POWER STROKE DIESEL V8

**1999.5
DIT Engine
Update**

1999.5 FORD CHANGES

All changes listed are for engine serial number 896812 and above unless otherwise noted. This publication is intended to provide technicians and service personnel with the latest technical advancements incorporated in the 7.3 DIT Diesel Engine. The information contained in this publication will supplement information contained in available service literature.

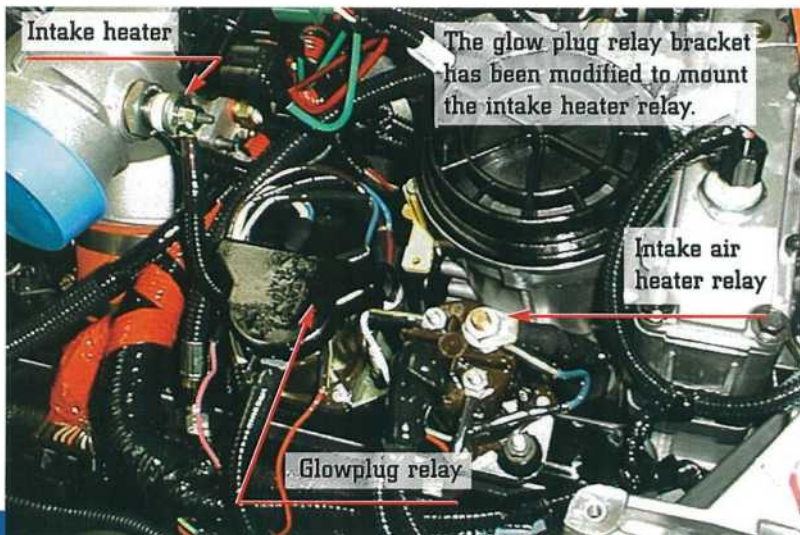
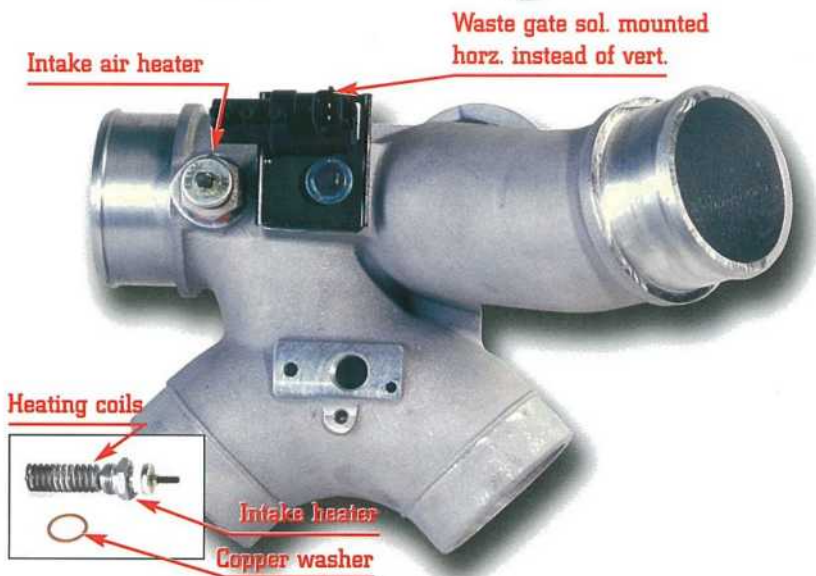
The turbo charger has been changed to improve efficiency. The diameter of the turbo compressor outlet, and the size of the compressor have increased to improve air flow capabilities of the turbo. Due to the increase in size, the new turbo is mounted on a taller pedestal to provide adequate clearance. A new exhaust inlet adapter has been designed to allow access to the fuel pressure test port at the rear of the head. The new exhaust inlet requires new exhaust up-pipes. The Econoline uses the new larger, taller turbo without the waste-gate or charge air cooling provisions.

A new CAC crossover has been developed for the new turbo and incorporates a PCM controlled intake air heater. The heater is installed in the air inlet to the engine (after the charge air cooler) side of the CAC crossover. On the Econoline the heater is in the "Y" pipe downstream of the turbo. The new intake heater is used to heat the air before it reaches the combustion chamber in the engine during cold startup to reduce cold smoke. Current to the intake heater is switched on/off by a PCM controlled relay, similar to the glow plug relay. In order for the relay to be activated the following conditions must be met: fast idle must be engaged, glow plugs must be off, PCM voltage must be between 11.8–15 volts, EOT (Engine Oil Temperature) must be below 55°C (131°F), and engine speed must be above 1000 RPM. In order for fast idle to be engaged the following conditions must be met: the vehicle must be in park or on a manual transmission the parking brake must be set, EOT must be below 70°C (158°F), IAT (Intake Air Temperature) must be below 0°C (32°F) for 1000 RPM and -10°C (14°F) for 1100 RPM, brake pedal must not be depressed, and accelerator pedal must be at idle. A 90° angled fitting for the map hose has also been installed so that a common straight MAP hose can be used for both the Econoline and the "F" series. With the increased turbo height and repositioning of the waste gate solenoid the wastegate hoses have also changed to fit the relocated components.

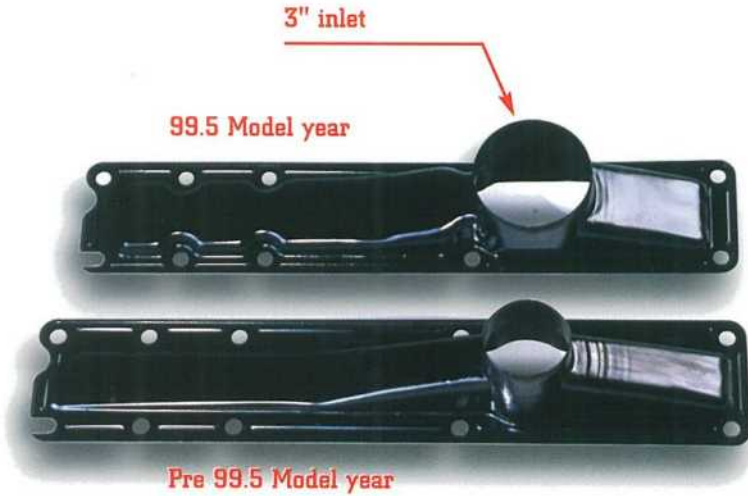
Both the Econoline and the "F" Series use a new intake cover with 3" inlets into the heads for better flow to the combustion chambers. The new cover has had no modifications to length or bolt pattern. With this change, the CAC to intake hoses are now straight with 3" diameters on both ends. These hoses have no hump between the two components. On the non charge air cooled Econoline engines, an aluminum "Y" pipe with 3" inlets and outlets is now used.

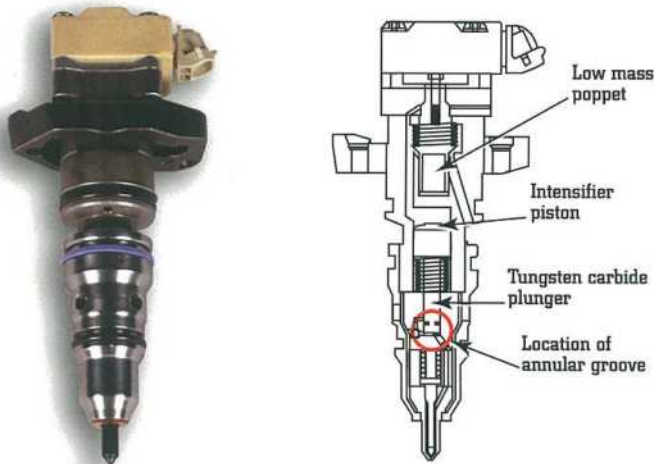
Due to the changes in turbo height, the turbo air inlet duct for both the Econoline and "F" Series have changed.
